V2500-A1/A5 SERIES PROPULSION SYSTEMS SERVICE BULLETIN

AIR – HP COMPRESSOR STAGE 7 BLEED VALVE – INTRODUCTION OF A BLEED VALVE SPACER

V2500-ENG-75-0092

Fig. 1

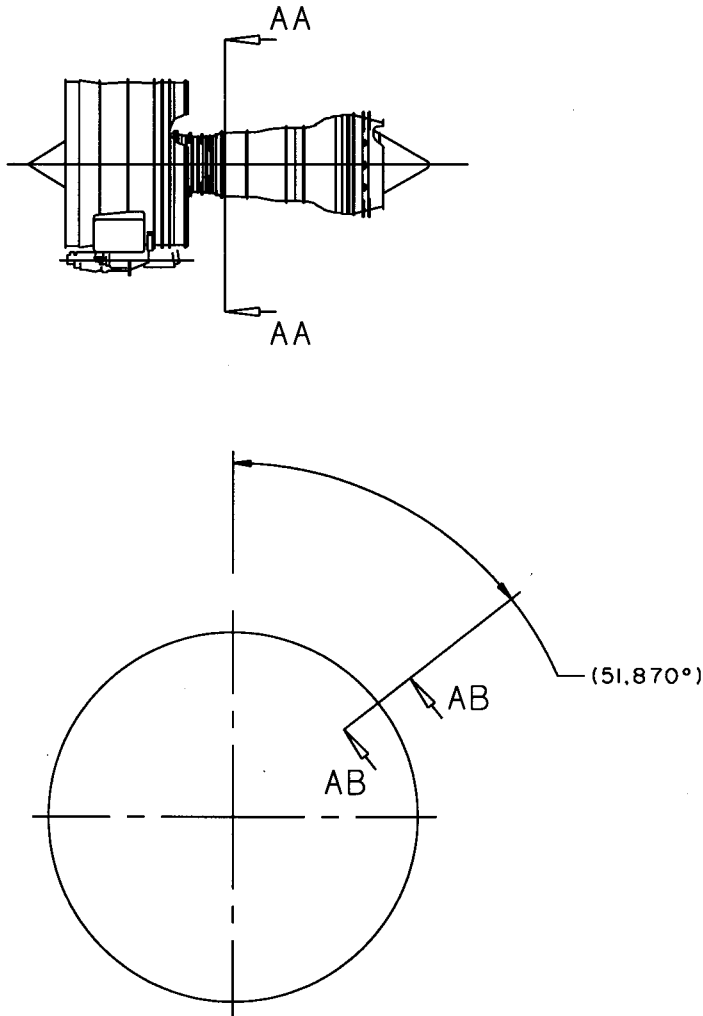
(a) A new spacer is introduced beneath the HP Compressor Stage 7A bleed valve silencer assembly.

(b) A revised bolt is introduced similar to the existing bolt except for an increase in length to accommodate the spacer.

- (iii) Torque the nuts to between 85 and 105 lbfin (0.96 and 1.18 m.daN).
- (g) Install the silencer assembly.
 - (i) Hold the silencer assembly and spacer 6A8319 in position on the bleed valve. Refer to Fig. 1 and Fig. 2.

- (ii) Attach the silencer assembly and spacer to the valve with bolts AS21013 and the nuts 4W0002. Refer to Fig. 1 and Fig. 2.
 - (iii) Torque the nuts to between 85 and 105 lbfin (0.96 and 1.18 m.daN)
